Flight Procedure Tracking Form		Action: FLIGHT CHECK	Task Type: IAP	Date Open: 04/03/2019	Task #: 2019040334265001003	Request #: 20190403342650
Procedure: HI - ILS OR LOC RWY 25 AMDT 9			Airport ID: KFMS	Airport: FORT SMITH RGNL		Reimbursable #: NO
City: FORT SMITH	ST: AR	GPS #:	Estimated Chart Date: 03/26/2020		FICO #:	
Fac ID: FSM		Fac. Type: ILS			Specialist: NICHOLAS JACKSON	
Procedure Review						
	Rec'd	Rel'd	Full Name	Comments		
Lead:	07/30/2019	10/31/2019	DONALD LANIER			
QA:	10/31/2019					
Liaison:						
Procedure Comments: ENROUTE-NON Remark Type: INFORMATION ACTIVE AIRPORT DATA UTILIZED PENDING FSM ILS DATA UTILIZED WIZER LOM (FS) AND JEMBO LOM (GK) DECOMMISSIONING APPROVAL LETTER REQUIRED FOR COMMISSIONED ILS GPA PROCEDURE WILL NEED TO BE REMOVED FROM FDC 9/3991 ON CHART DATE CONTACTS: DONALD LANIER 405.954.8242 OR GEORGE DAVIS 405.954.9960

PROCEDURE REVIEW BOARD (PRB) RESULTS

2. Approval: (FSM) FORT SMITH RGNL, FORT SMITH, AR - HI - ILS OR LOC RWY 25 AMDT 9

PRB Result: RETURN FOR REWORK

HI-ILS or LOC RWY 25
FORT SMITH RGNL (F'SM)

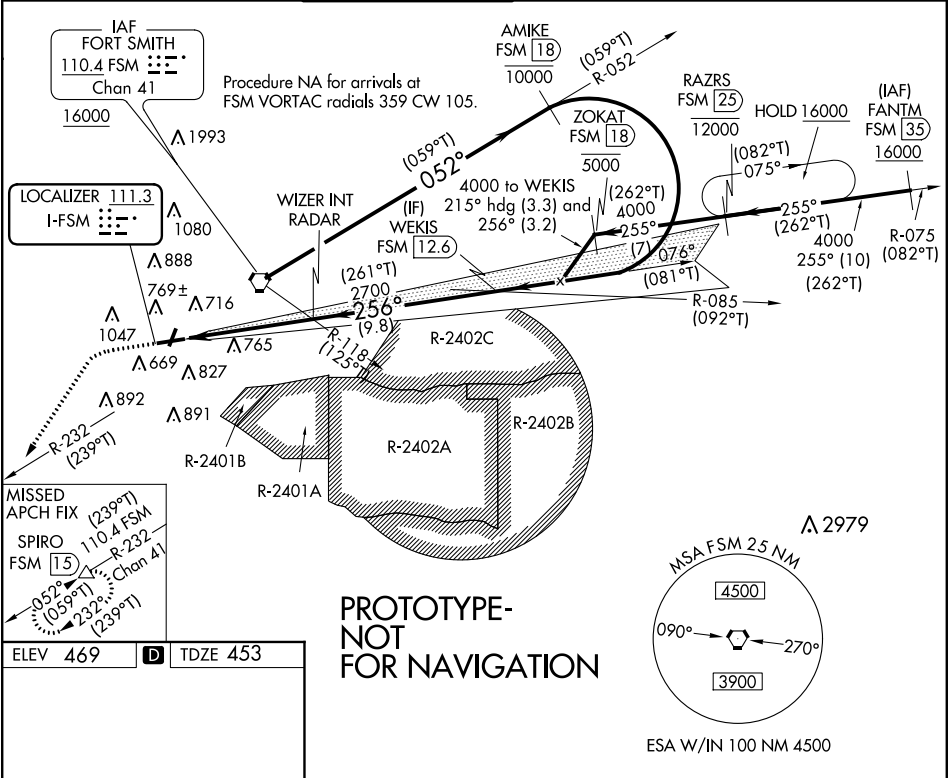
- a. Form 8260-9 is missing.
- b. Line 15, Changes, shows: 15. ALTERNATE MINIMUMS FOR CAT D/E CHANGED FROM: CAT D 800-2 1/4, CAT E 800-2 3/4 TO 1000-3. - S-LOC 25 MDA/HAT DAT INCREASED. **DAT** should be **HAT**.
- c. Additional information
 - 1) Package contains obsolete approval letter (pdf page 17) addressed to Bruce DeCleene and Danny Hamilton that should be removed.
 - 2) FIG contains a Chart error in the missed approach box - it shows FSM R235 and it should show FSM R232.

A. 8260-9 included.
B. Line 15 updated to reflect HAT in lieu of DAT.
C. 1. Approval letter updated to reflect managers Doug Rodzon and Wade Terrel.
C. 2. FIG updated to reflect FSM 232 in lieu of FSM R235 in missed instructions.
